**Planning Department
Transportation Development Services Section**

Re: Certification Submittal for Final Building Certificate of Occupancy for
Richmond Street Studios, [K-16 / D66]
117 Richmond SE
Architect's Stamp Dated 12/13/06

Re: Certification Submittal for Final Building Certificate of Occupancy for
Richmond Street Studios, [K-16 / D66]
117 Richmond SE
Architect's Stamp Dated 11/15/06

DRIVEPADS

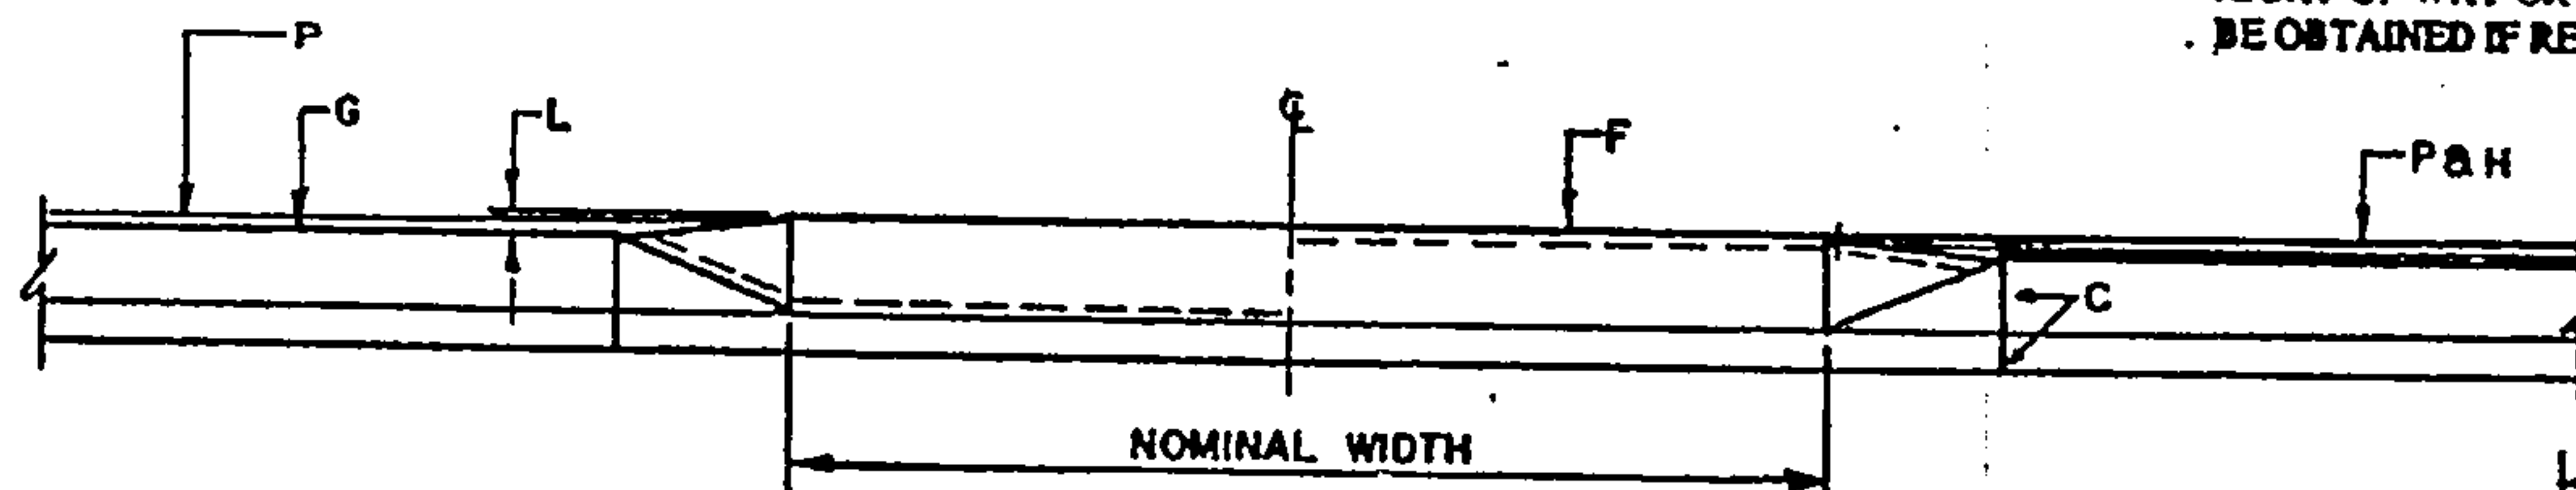
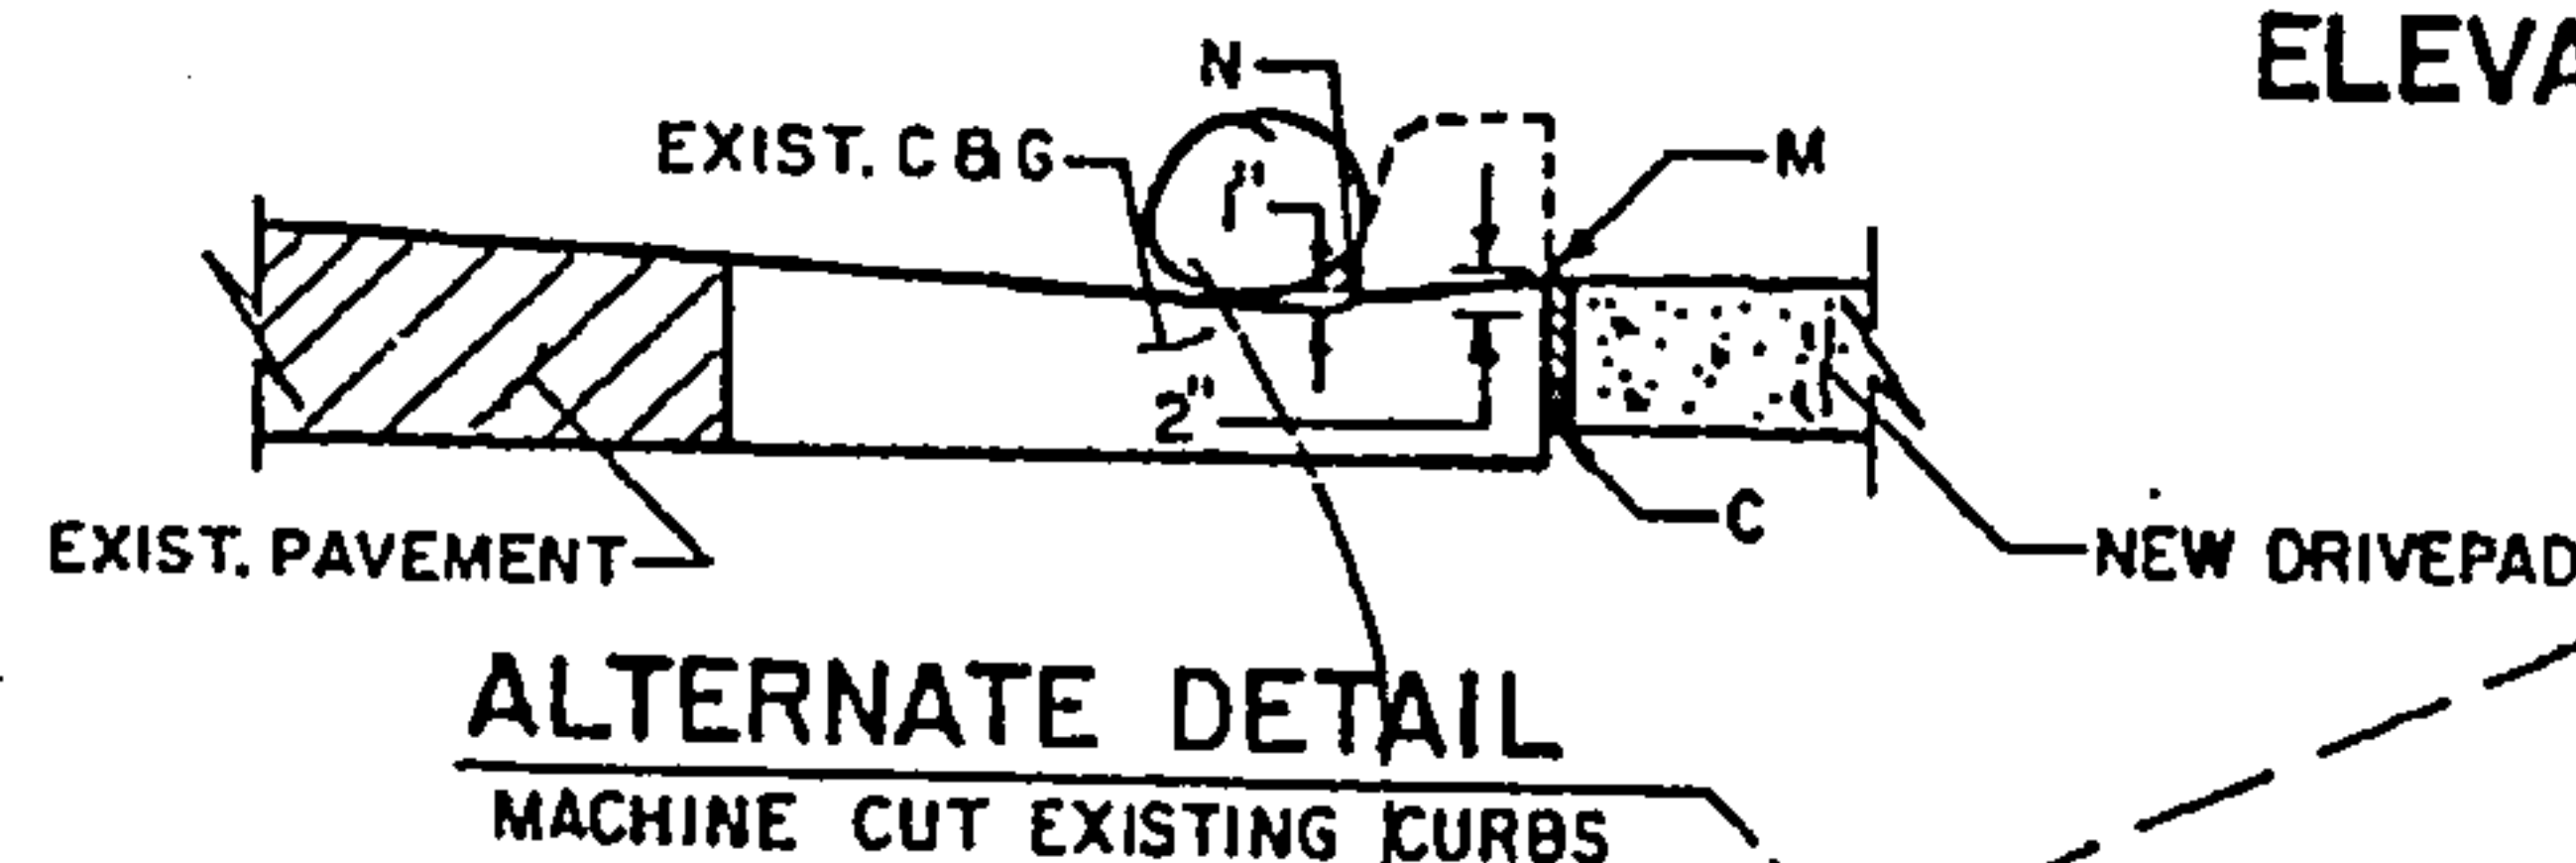
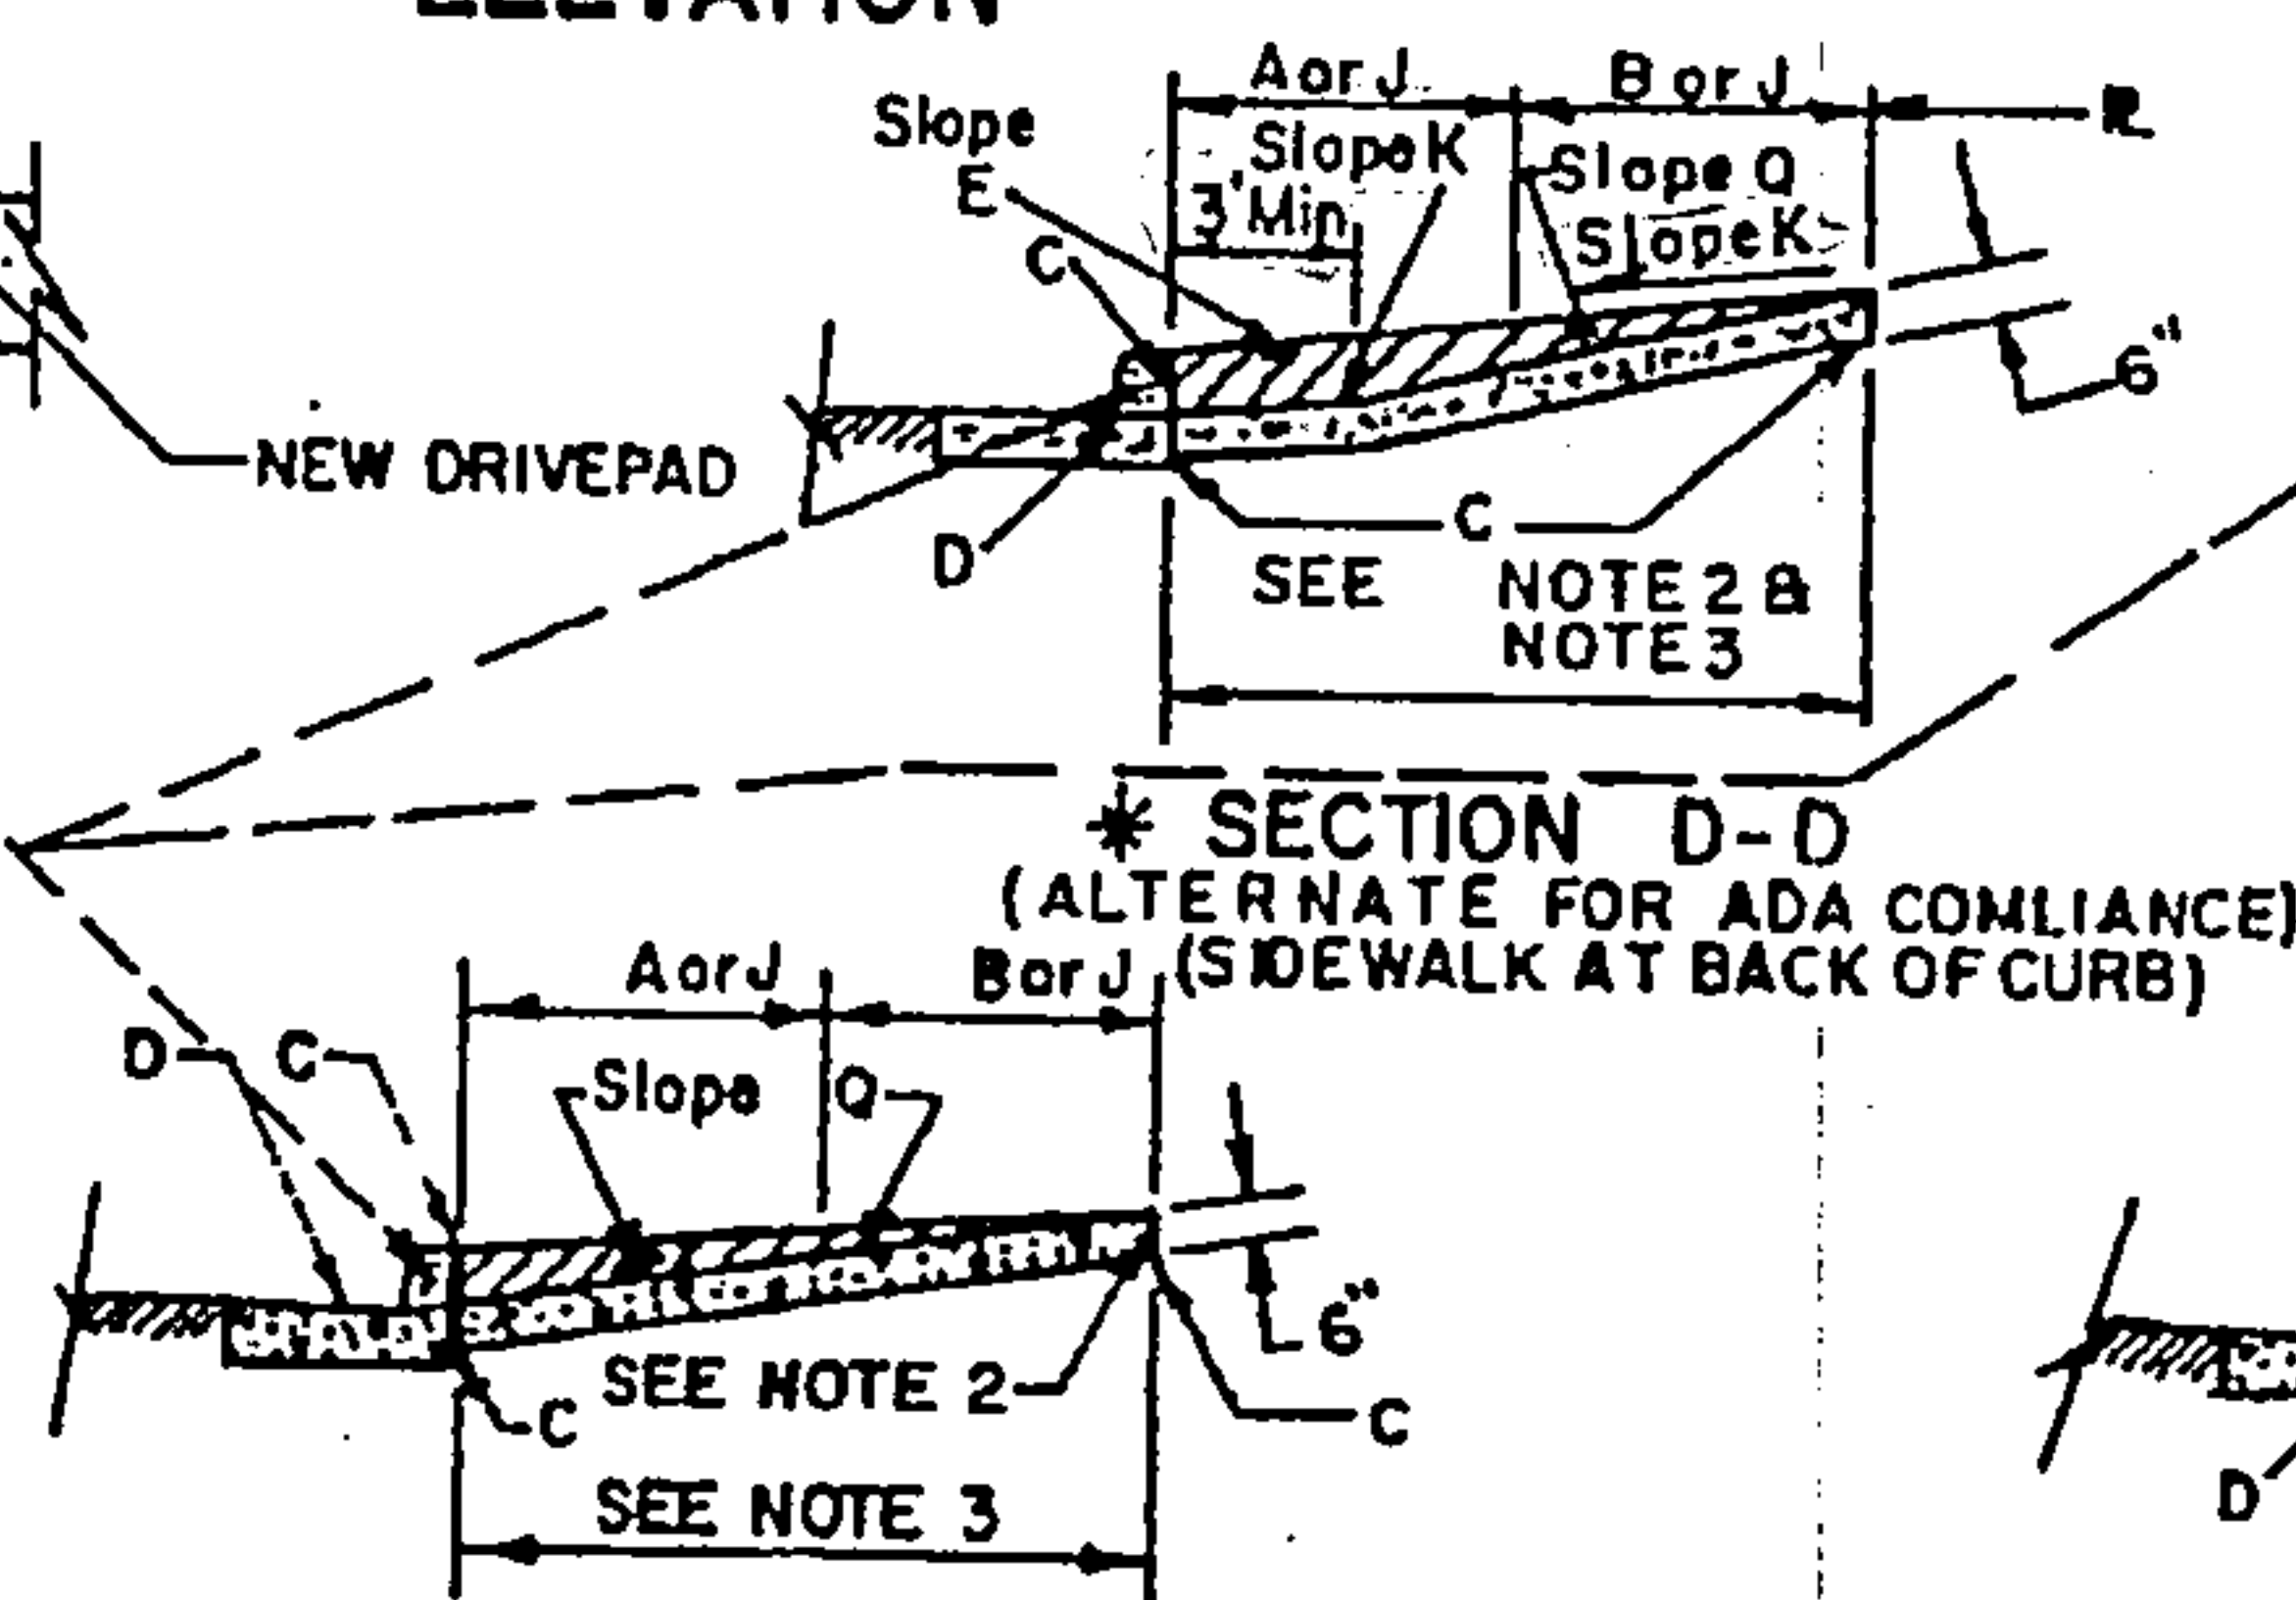
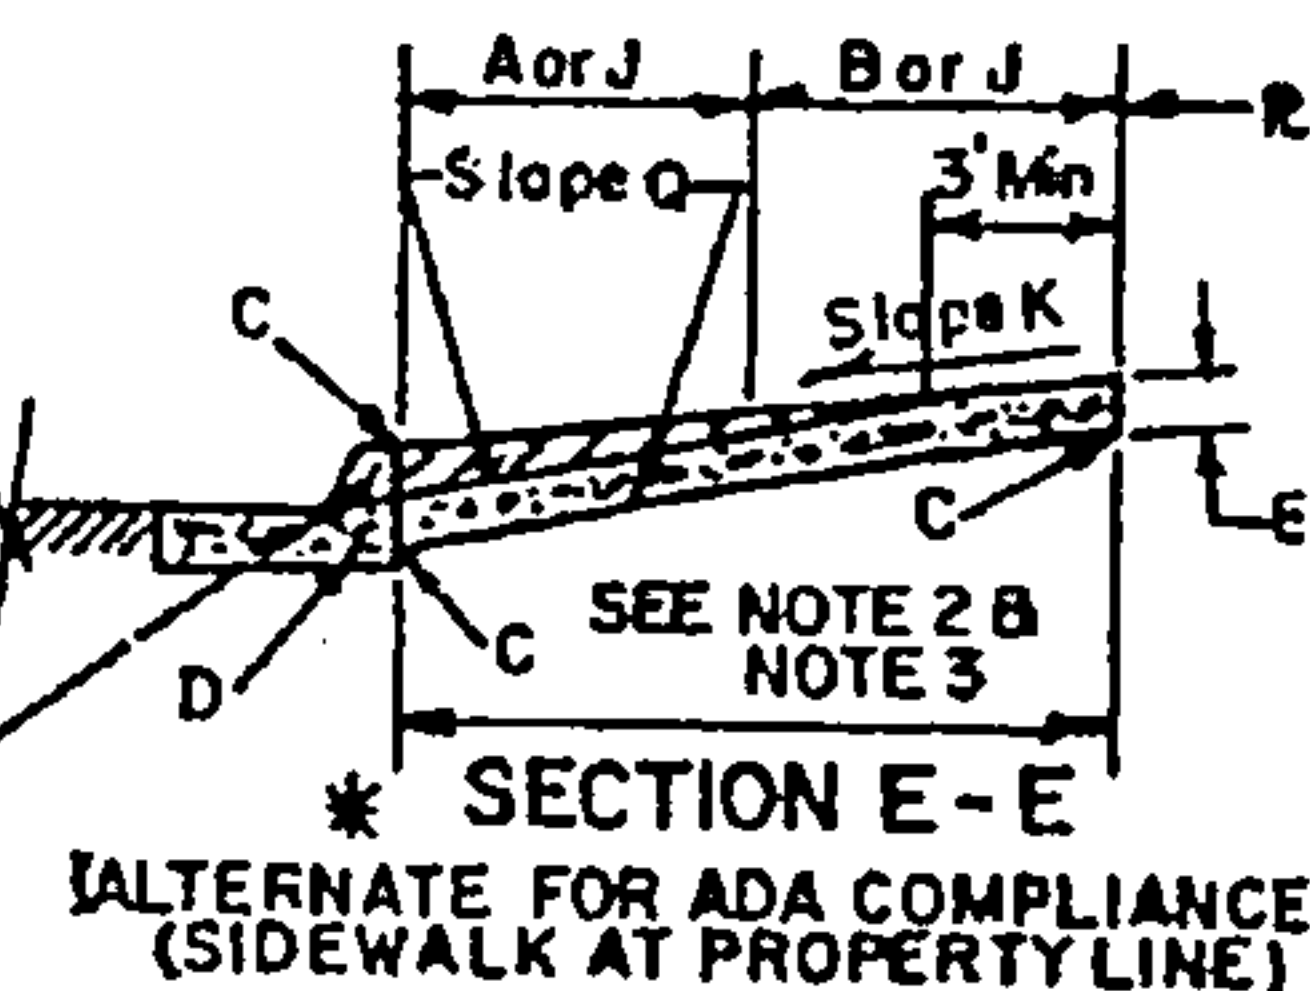
The TCL / Letter of Certification submitted on November 15, 2006 is not sufficient for acceptance by this office for final Certificate of Occupancy (C.O.). The Letter of Certification needs to have the following phrase as part of your wording, 'Substantial Compliance'. The entrance to the studio has need been constructed per the approved site plan. The drivepad needs to provide an ADA access route across the entrance which is not the case in accordance to field inspection.

I am resubmitting this Traffic Circulation Certification for Final Certificate of Occupancy for our project the Richmond Street Studios at 117 Richmond, SE. We have successfully addressed issues related to an ADA access route across the entrance drivepad per your field inspection instructions stated in your letter of November 16, 2006.
